Glen Innes to Tāmaki Drive Shared Path

Your feedback on Section 4 (Ōrākei Basin to Tāmaki Drive)

December 2021

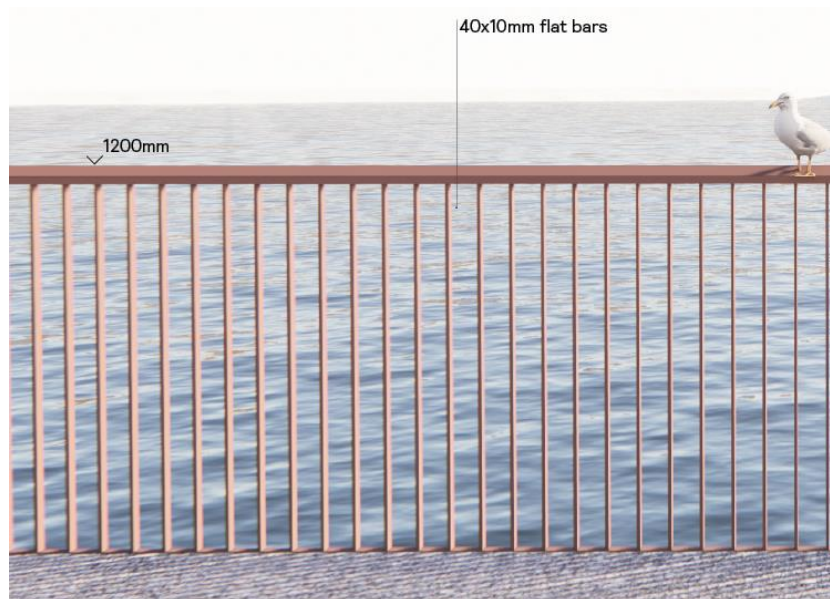
Overall, we have received very complimentary feedback about the design of the bridge and boardwalk. Nonetheless, 15 people (4.2%) did voice concerns about the balustrade design. This was largely related to concern about the level permeability (visibility through the slats or balusters – 5 people) or that the slats could create a ‘tunnelling effect’, which people associated with the original balustrade on Section 3, the Ōrākei Basin Boardwalk.

Balustrade dimensions: 40x10mm bars @100mm spacings, perpendicular to the boardwalk. 1.2m high.

The balusters are very similarly sized and spaced to the Section 3 design. The Section 4 design uses 40x10mm steel flat bars for weight bearing – this means wooden posts, or a similar support, spaced at regular intervals is not required. (On Section 3 support is provided by 10cmx10cm wooden posts every 1.1m). Overall, this give the Section 4 balustrade a sleek, sinuous design and is visually less intrusive. It also provides a less interrupted view. (See below image)
